Access Compliance Report

Public Rights-of-Way

| Intersection ID: 21804 | Main Street: NOLLEY_CT | Cross Street: GALLERIA_BV | Location: SW |
| ADA ID: 84B6C1C203E1 | Ramp Type: Perp | Initial Pass/Fail: Fail | Overall Compliance: No |

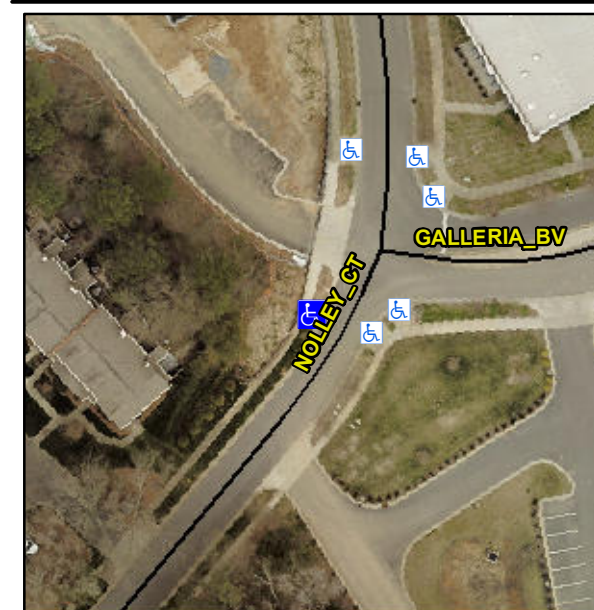
Not Found, R304.2.2

| Compliance | Description | Data | Compliance | Description | Data |
|------------|-----------------------|-------|------------|-----------------------------|------|
| N/A | Ramp Length (in) | 108.0 | No | Ramp Slope (%) | 9.2 |

Remove & Replace Entire Ramp.
